# 461 CHAPEL ROAD

BANKSTOWN 2200

DESIGN REVIEW REPORT

07 / 04 / 2025

**ITEM 02.01 - ENTRY FORECOURT - MORE GENEROSITY**

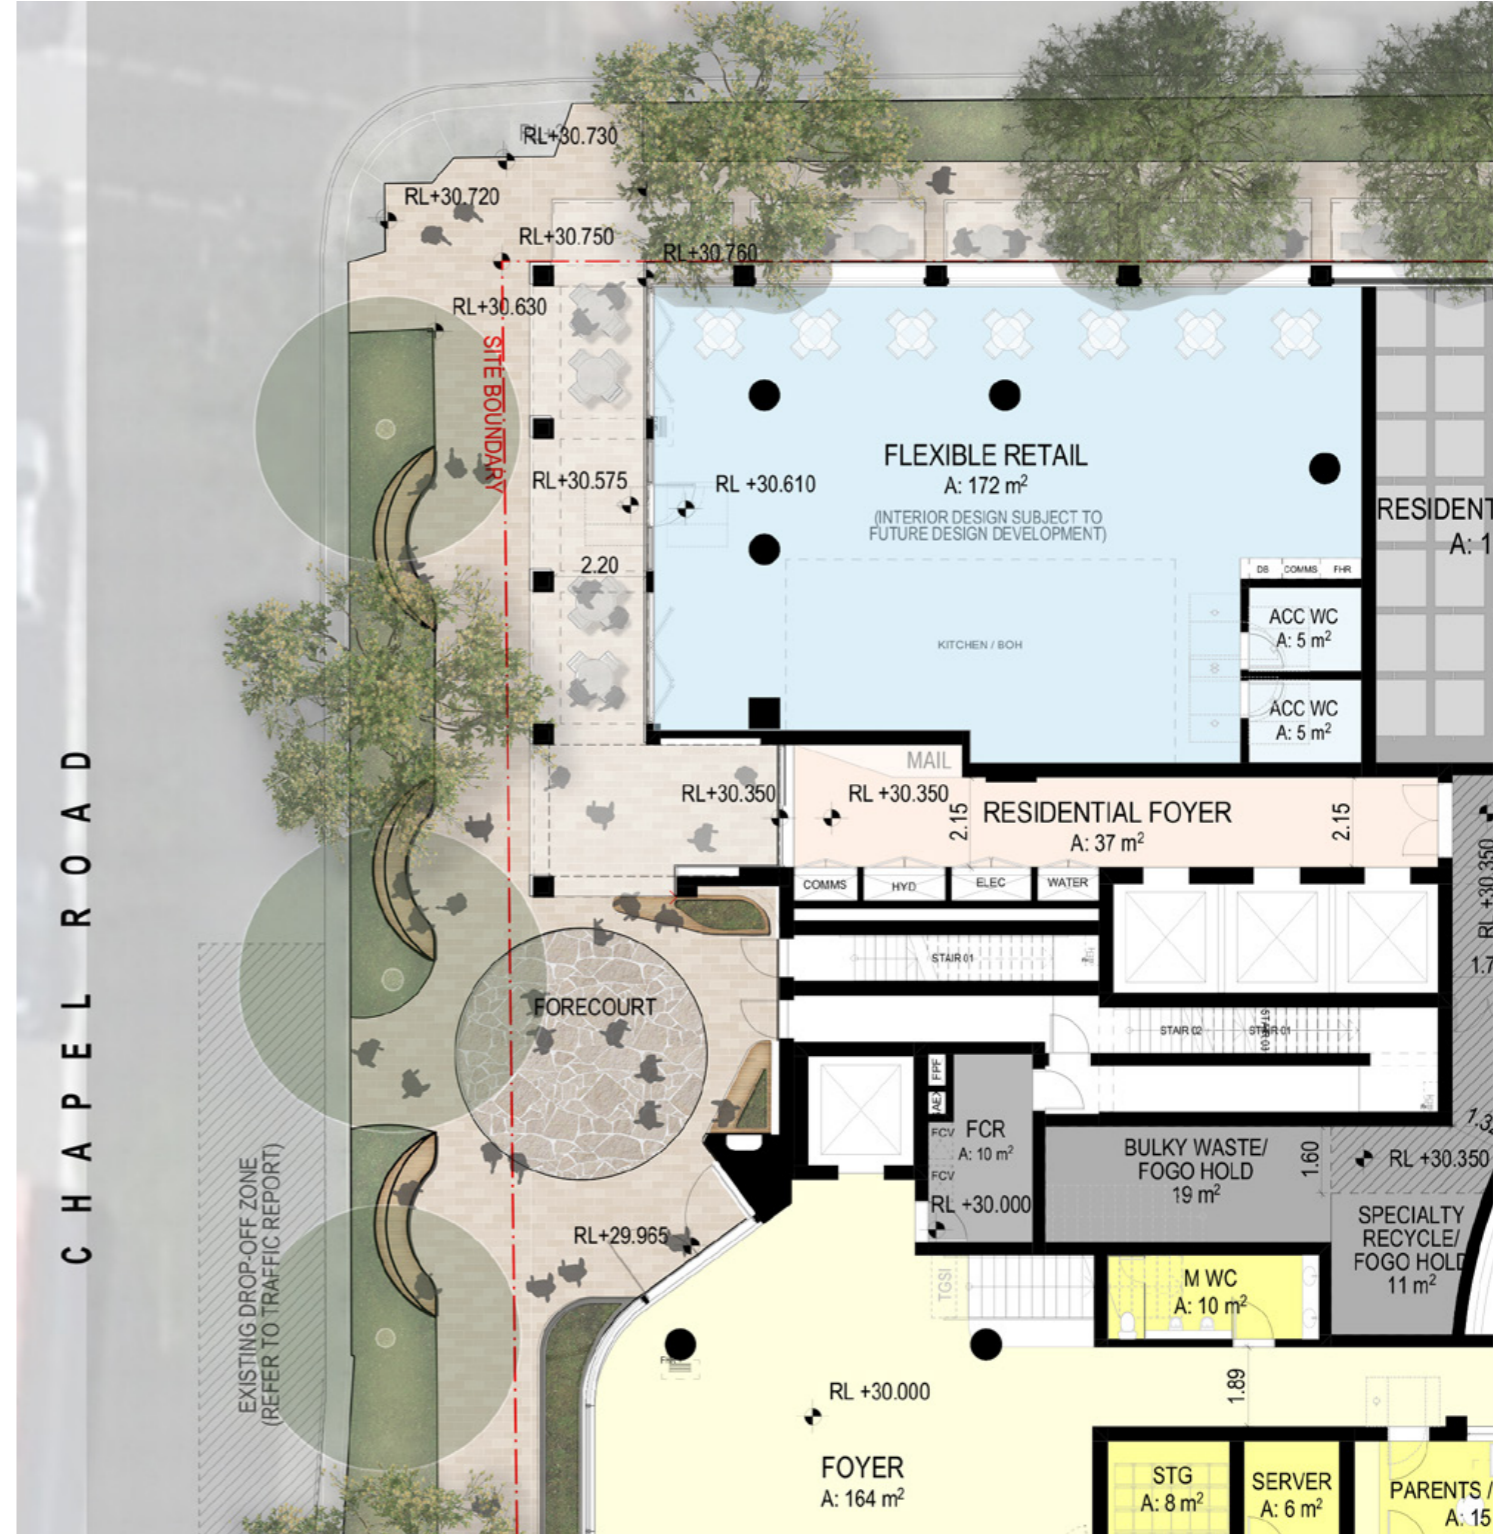
Provide more generous space to the Chapel Road frontage to reinforce its civic role and encourage community gathering e.g. a colonnade to define the street and provide various spaces for gathering.

In response to the SDRP feedback the proposal was amended to push the retail back create a colonnade at the corner of Chapel Road and French Avenue that will provide additional area for pedestrian movement and gathering space around the community facility.

In addition, a drop-off zone and additional public domain landscaping, which extends to the corners of the site, have been introduced in order to better accommodate community gathering and crowds during special occasions.

### ITEM 02.02 - DROP OFF ZONE

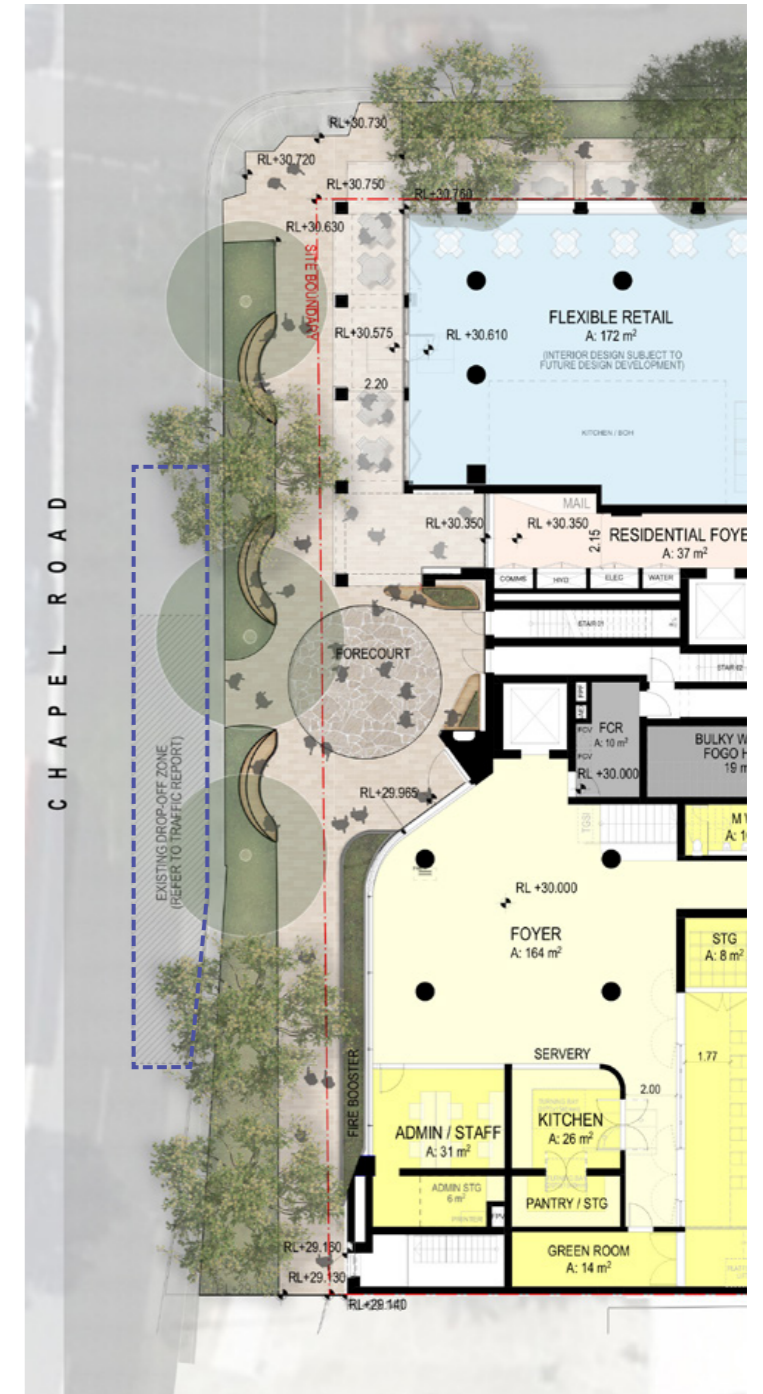
Identify locations for DDA parking, drop-off and pick-up bicycles and church vehicles e.g. wedding cars, hearse.

There is an existing parking zone on Chapel Street that is dedicated to funeral and wedding vehicles. A new 'drop-off' zone is proposed along the Chapel Road frontage of the site for the length of three (3) car parking space. The 'drop-off' zone will serve as short-turnover spaces for visitors to the subject site. The request for parking restriction changes will be formally made to the Local Traffic Committee once development approval is obtained.

**ITEM 02.03 - EARLY LEARNING CENTRE EXTERNAL AREA COMPLIANCE**

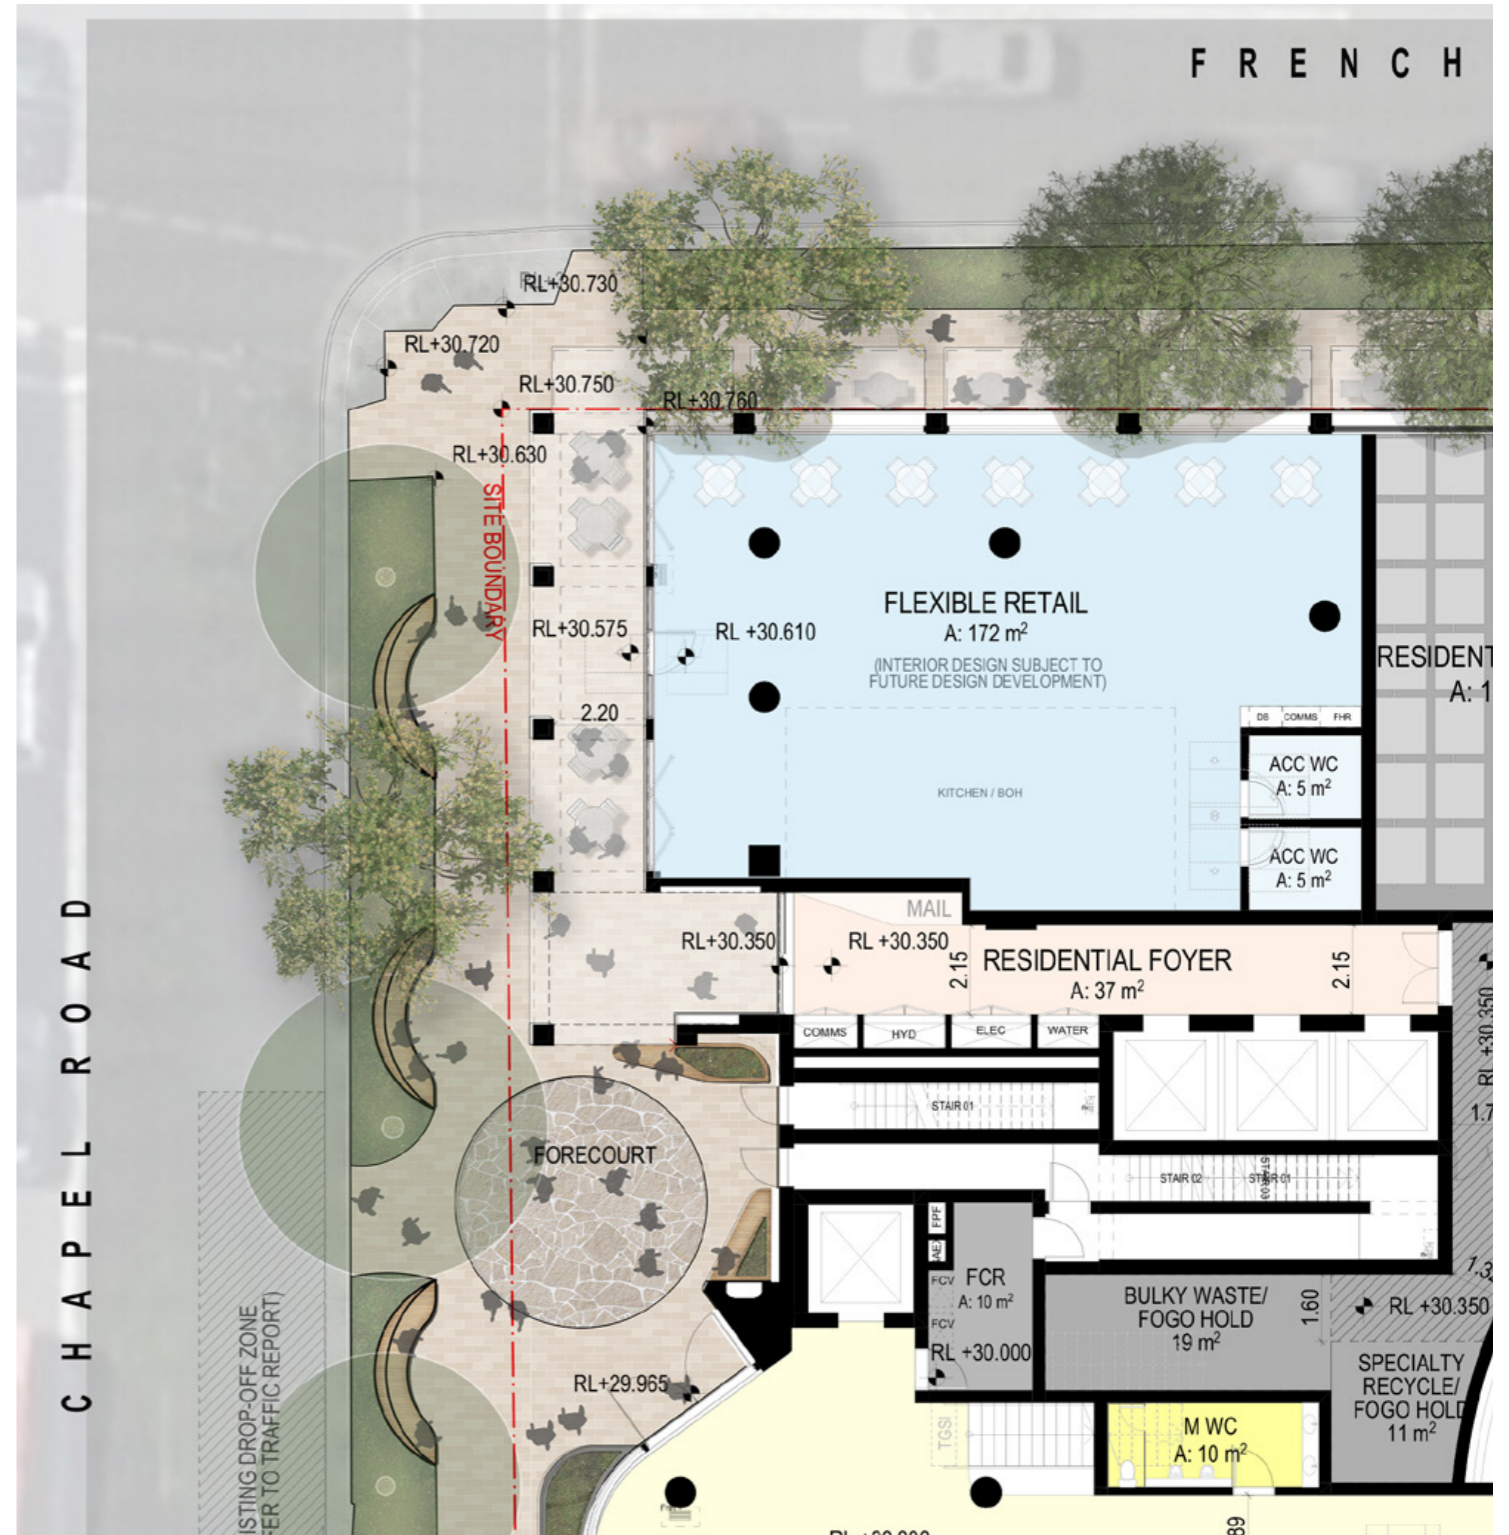
Demonstrate how the design early learning centre external area complies with NSW guidelines

Demonstrate how the public domain design accommodates movement function and intuitive access, balanced with landscape and activation opportunities.

Set back the retail to protect outdoor dining from pedestrians and integrate weather protection e.g. colonnade or continuous canopy

The Education and Care Services National Regulations apply to the childcare component of the development, setting out minimum requirements for unencumbered indoor and outdoor space.

For a childcare centre accommodating 50 children, the regulations require a minimum of 162.5m<sup>2</sup> of indoor space and 350m<sup>2</sup> of outdoor space. The proposed childcare centre exceeds these requirements, providing 218m<sup>2</sup> of indoor space and 355m<sup>2</sup> of outdoor space, thereby ensuring full compliance with the applicable regulatory standards.

The public domain design will accommodate movement function and intuitive access and will balance this with landscape and activation opportunities. This is addressed below:

a. The proposed awnings have been removed to extend the colonnade further out, facilitating pedestrian mobility and providing protection from all types of weather. The existing trees along Chapel Road will be retained and offer canopy cover to provide shading and further weather protection, whilst offering benefits to the local ecosystem.

**ITEM 03.03.b - NORTH & WEST FACADE DESIGN FOR CLIMATE**

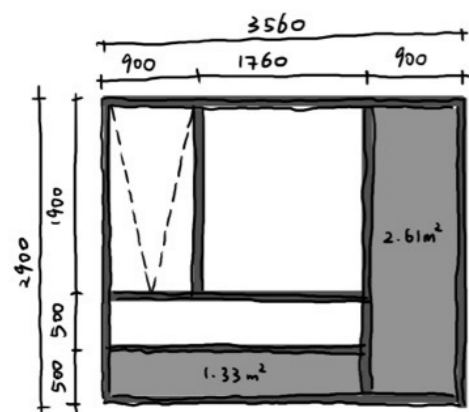
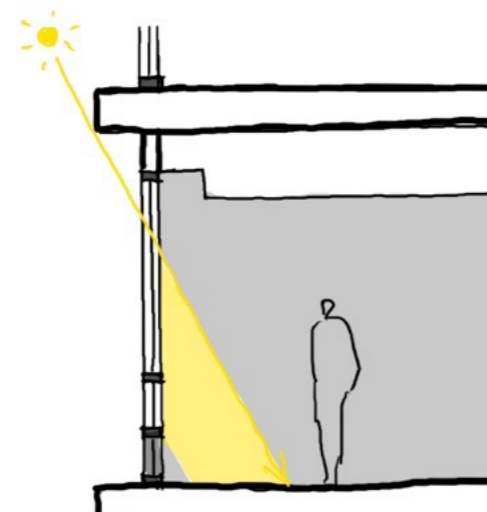
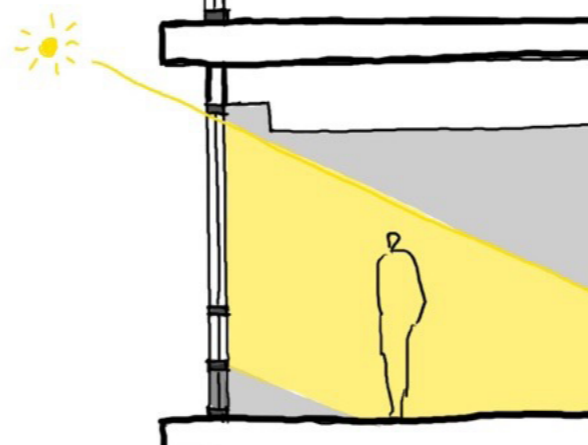
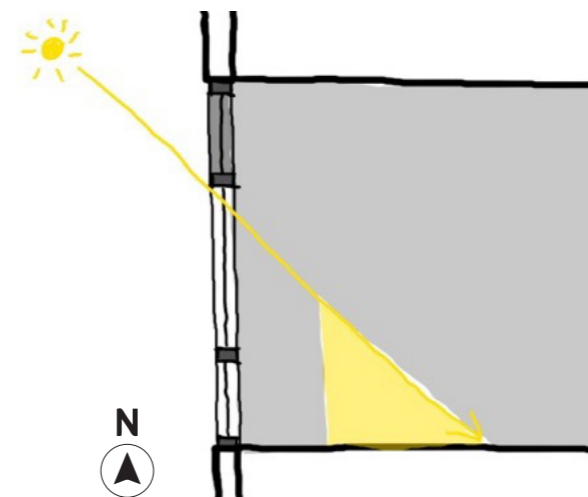
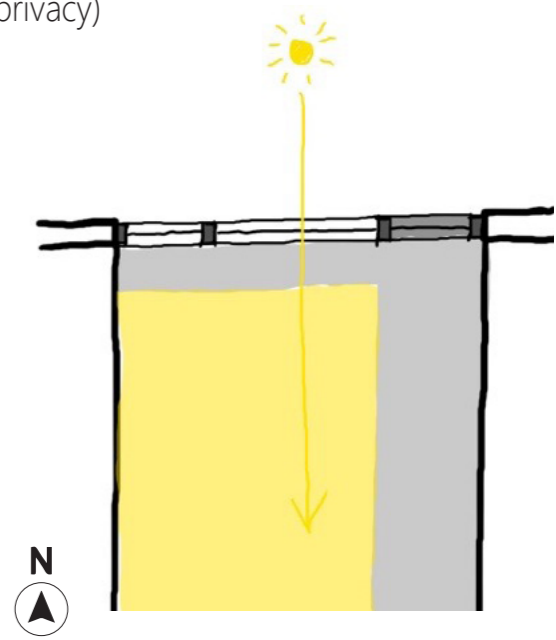
Integrate sun-shading to the facade particularly on the west

Various amendments have been made to the façades to address this feedback.

- A universal window system has been adopted to accommodate both the north and west solar conditions, with a 38% reduction in glazing area.

- Principles:
  - Horizontal elements are most effective.
  - Winter sun is desired, summer sun needs to be blocked.
- Design elements:
  - Exposed slab edges
  - Horizontal colourback spandrel at 500mm height (for solar & privacy)

- Principles:
  - Vertical elements are most effective.
  - Winter sun is desired, summer sun needs to be blocked.
- Design elements:
  - Vertical spandrel colourback spandrel
  - Horizontal colourback spandrel at 500mm height (for solar & privacy)
